**RESPONSE TO REQUEST FOR
FURTHER INFORMATION**

**PROPOSED B.T.R. RESIDENTIAL DEVELOPMENT
at DALGUISE HOUSE, MONKSTOWN, CO DUBLIN**

JULY 2023

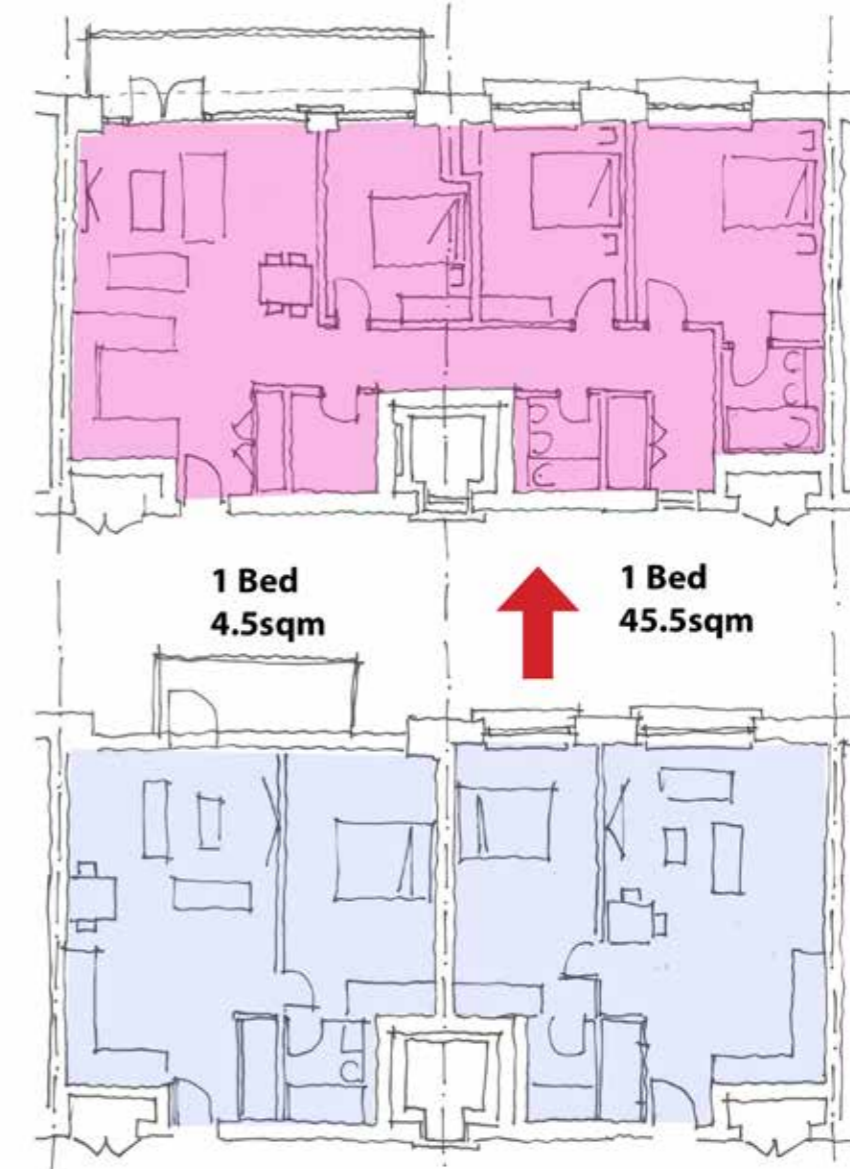
The applicant has stated that Blocks H, i1 and i2 and the Coach House could be purposed as 'Build-to-Sell' units as described by the applicant.

However, these Blocks and the Coach House units do not comply with the criteria set out in the Apartment Guidelines and County Development Plan 2022-2028 (Chapter 12), in respect of mix of units, open space, private amenity space, parking proposals, storage etc.

The Applicant is requested to submit revised details/ drawings which clearly sets out how Blocks H, I1, I2 and the Coach House meet these standards.

A number of the Blocks in this proposal are being identified as 'Build to Sell' enabled. This means that each Block is appropriately sized in order to comply with the BTS size standard. This allows for possible future adaptability which would involve the addition of balconies and a change in the mix to make each Block fully compliant in the event that they change to BTS. These Blocks include the following :

- Block H : 8 Apartments (15%)
- Block I(x2) : 12 Apartments (50%)
- The Coach House : 3 Apartments (100%)

To make these apartment Blocks fully compliant in the future, bolt on balconies would need to be added to the remaining percentage of apartments. This could be done quite simply with balconies that affix to the facade and can be easily accessed by each apartment to achieve level access for residents, the mix could also be changed in order to meet the BTS mix by changing the 1 beds to 3 beds. (2x1 beds = 1x3 bed)- please see flexibility diagram opposite. It should also be noted that all apartments comply with the Design Standards for New Apartments (Dec 2022) in terms of storage, dimensions and room sizes.

Please refer to drawing MKS-RAU-NW-ZZ-DR-AR-100 - North West Houses and updated HQA accompanying this application.

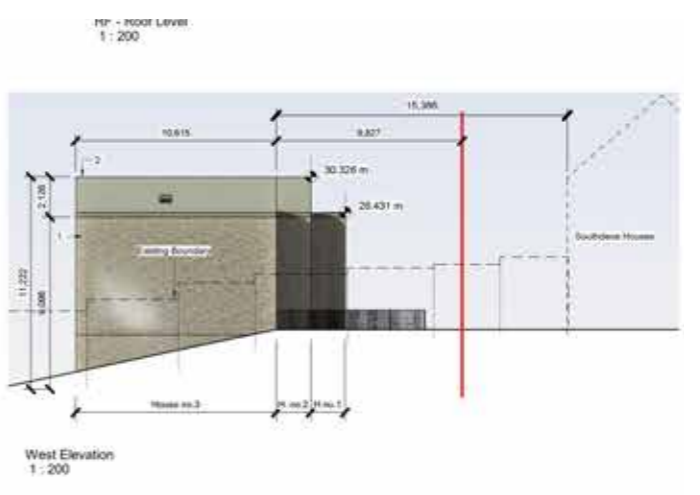
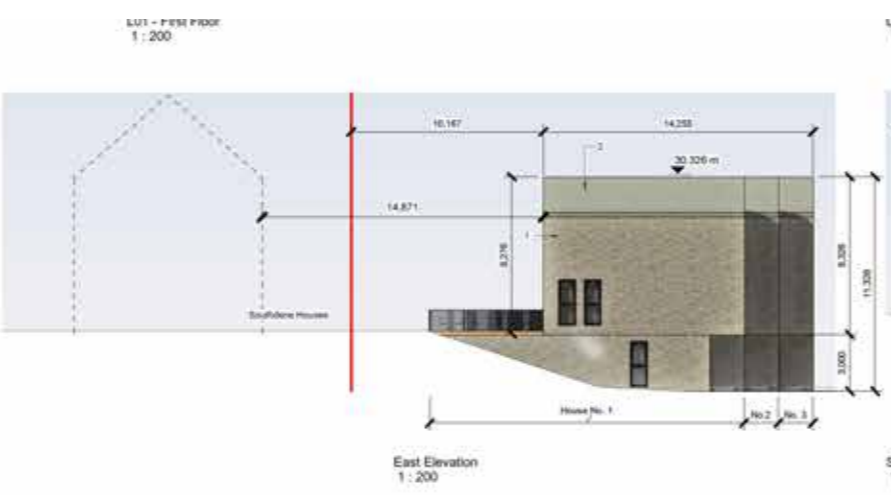
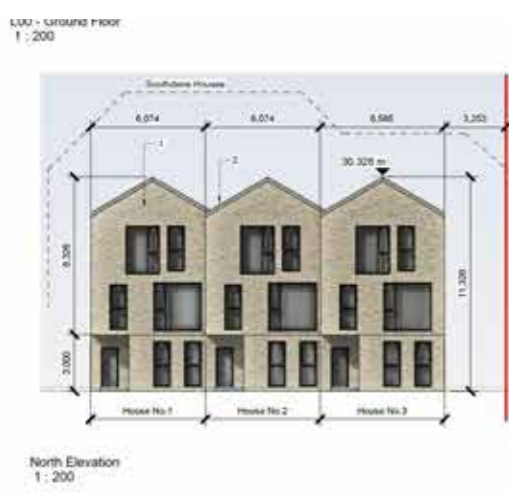
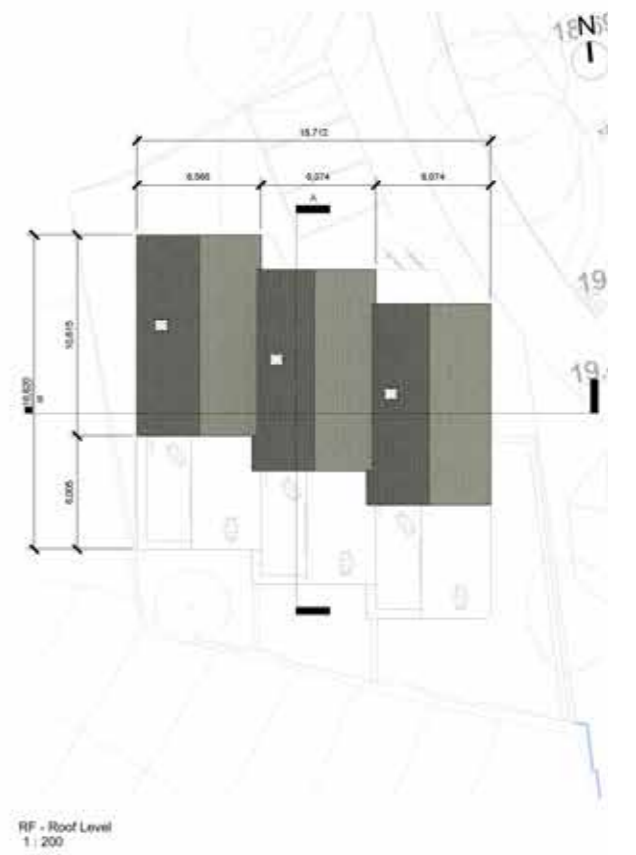
The private amenity area/ rear garden areas for the proposed 3 no. dwellings have not been quantified. From assessment of the submitted details, it is considered that the proposed rear amenity spaces fail to accord with Section 12.8.3.3 Private Open Space, of the County Development Plan 2022-2028. The Applicant is requested to revise same to accord with the provisions of the County Development Plan.

The North West Houses private amenity spaces have been updated to comply with Section 12.8.3.3 for Private Open Space in the Dun Laoghaire Development plan 2022-2028.

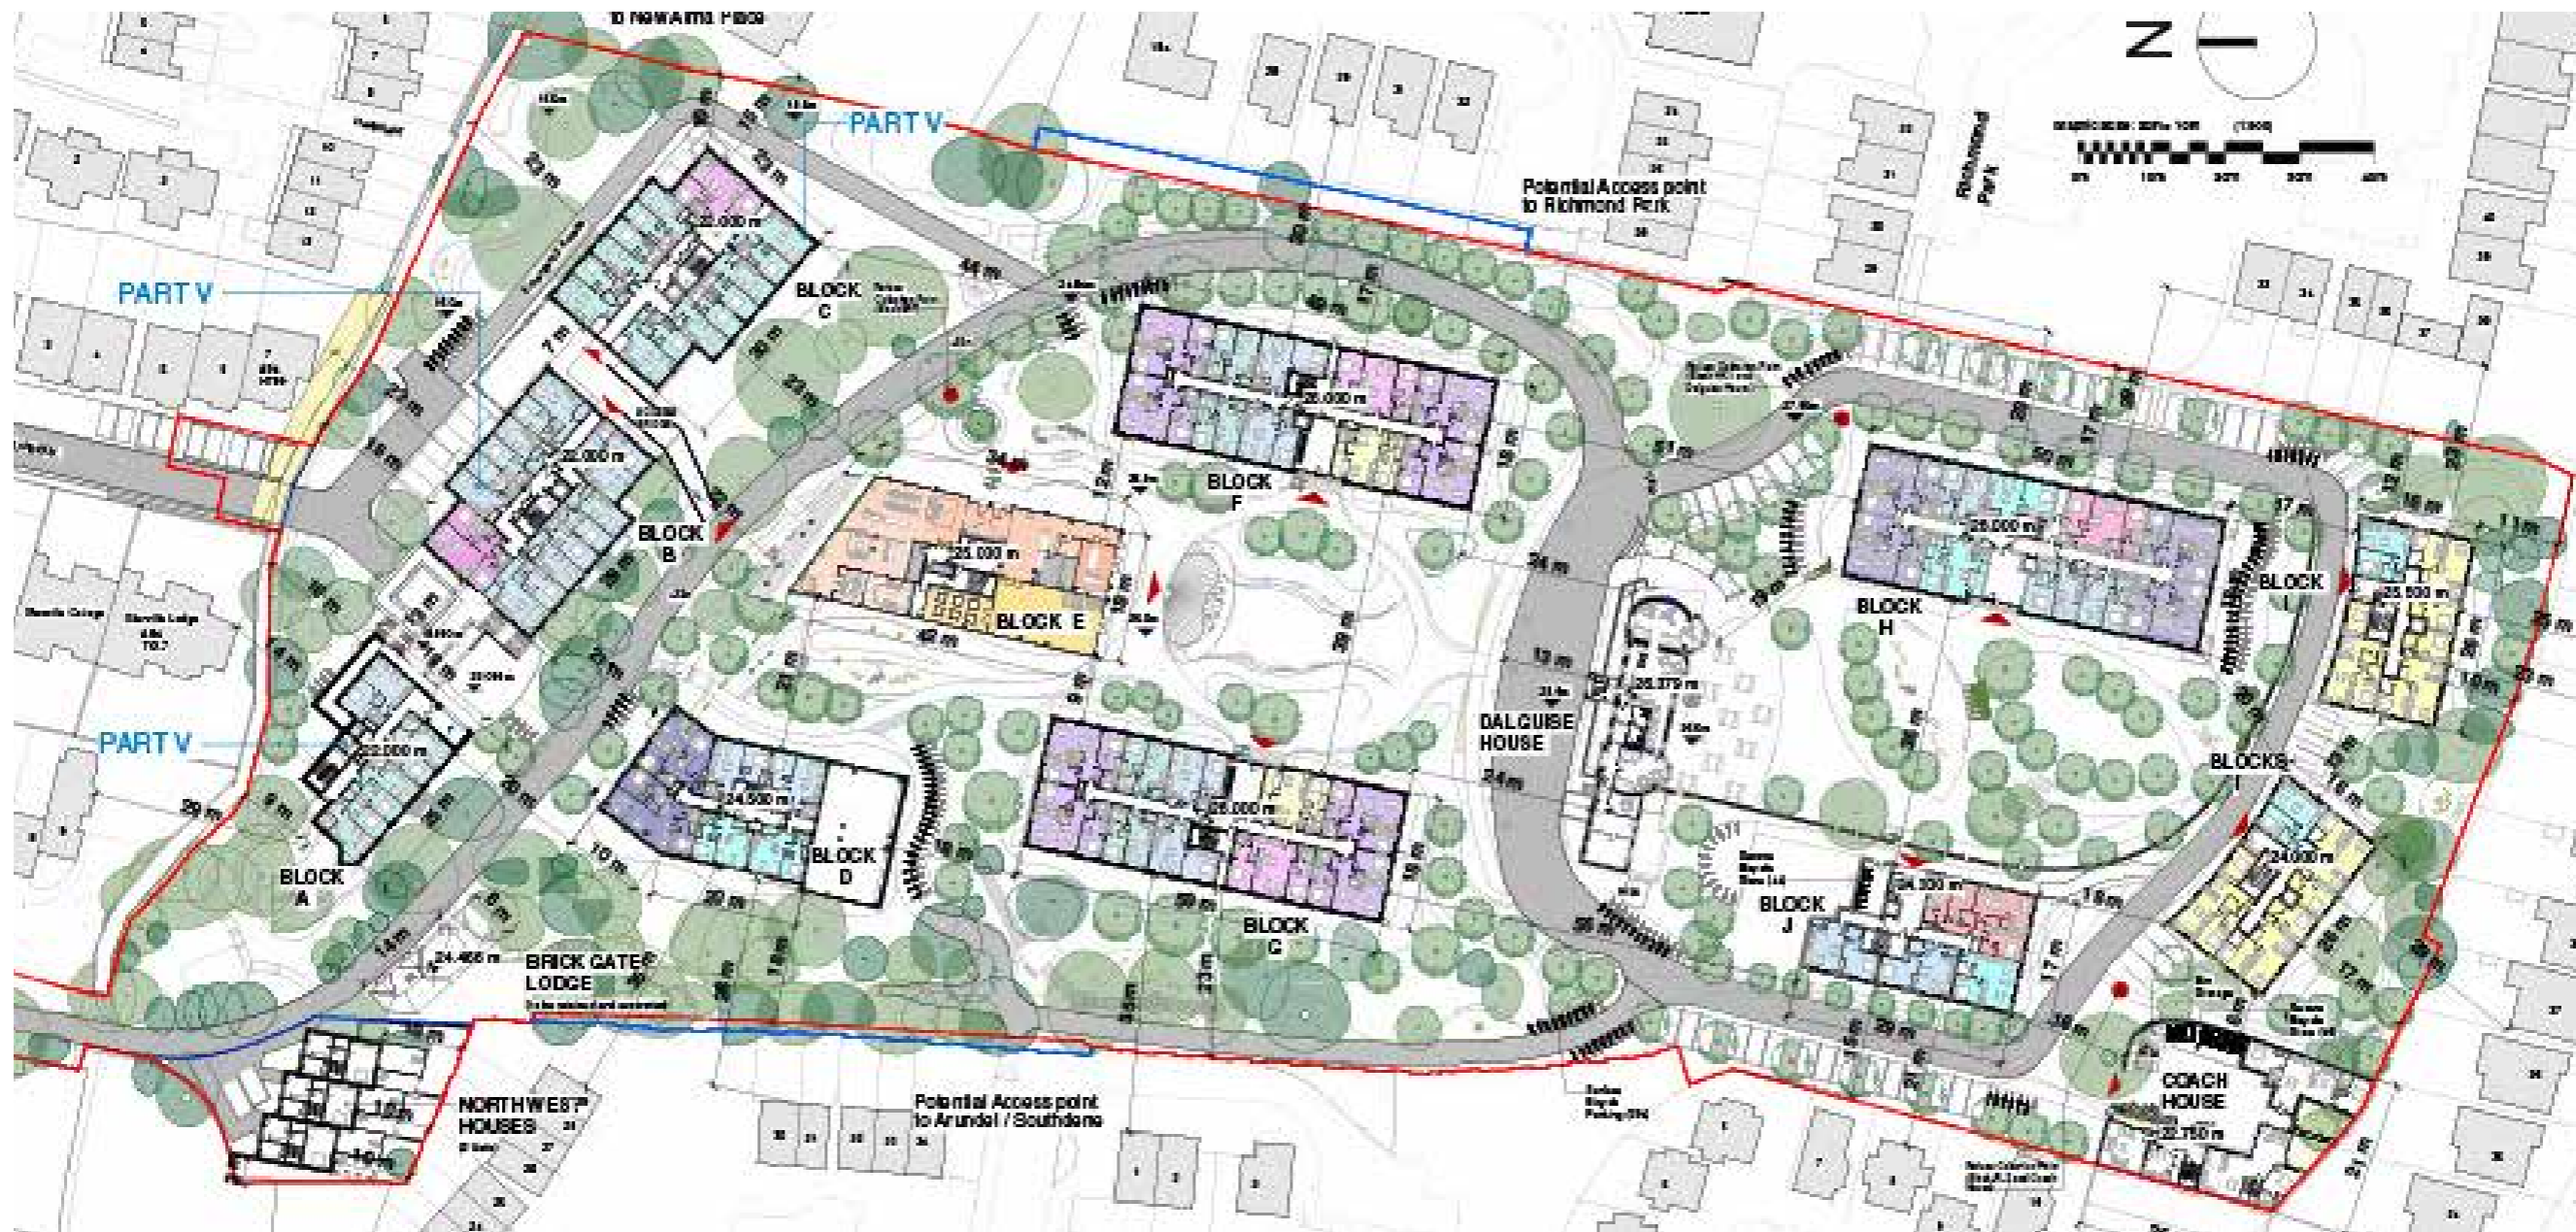
The Applicant is requested to submit revised drawings and details which demonstrate the provision of accessible parking spaces which are suitable for use by people with disabilities adjacent to Blocks I & J.

In response to this concern, 2 accessible car parking spaces have been provided beside Blocks I and J. Please refer to drawing MKS-RAU-ZZ-00-DR-AR-100 for further details.

Scheme as applied

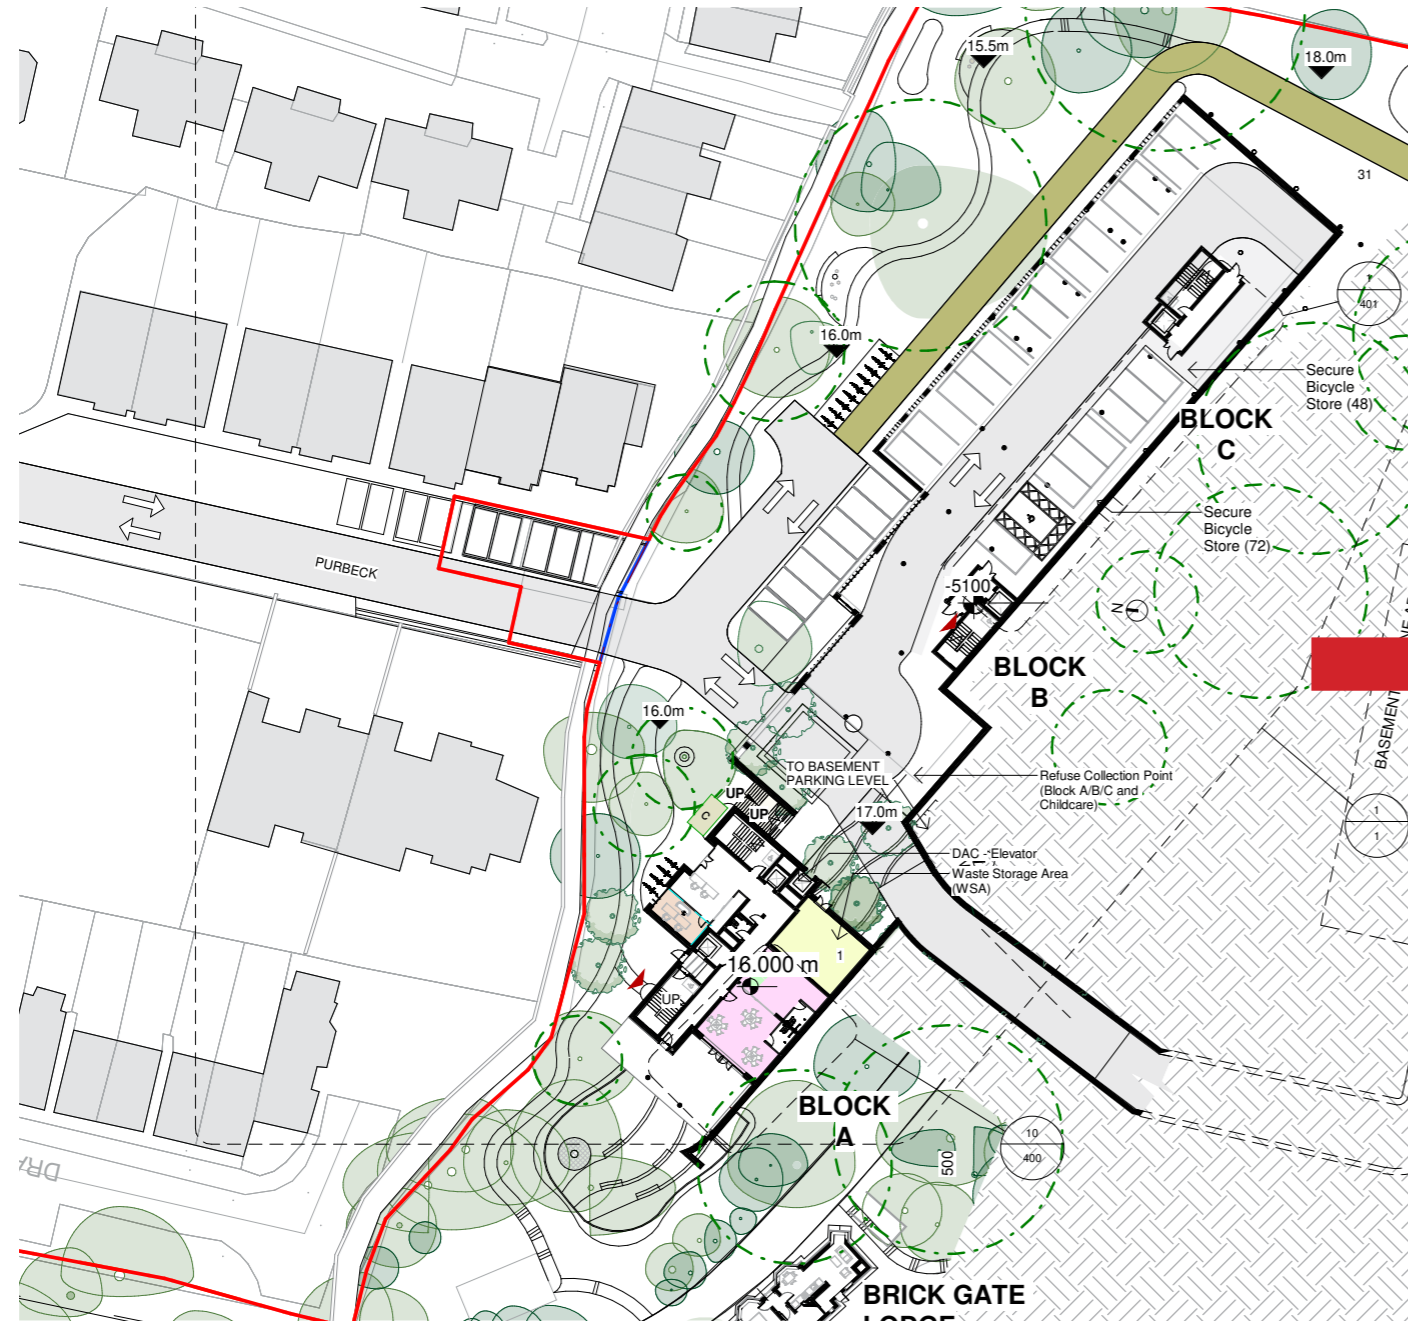
In accordance with Section 12.4.9 Design of Underground and Multi-Storey Car Parks of the current DLRC County Development Plan, the Applicant shall submit drawings and details which clearly demonstrate that the proposed basement/undercroft parking meets the requirements set out in the UK's Institution of Structural Engineers booklet entitled 'Design Recommendations for Multi Storey and Underground Car Park Fourth Edition' (2011) and any subsequent updates. The following items in particular shall be clarified and addressed:

The basement car parking design has been re-configured to allow for ease of access, minimise mixing of different modes - cars / bicycles and designing out any non compliant turning radii in accordance with the Design Recommendations for Multi-Story and Underground Car Parks. The following changes have been made :

- Re-alignment of the access road into the Basement which allows for a more direct access and thus avoids any excessive turning radii.
- The creation of a separate cycle route into Block D and the Basement.
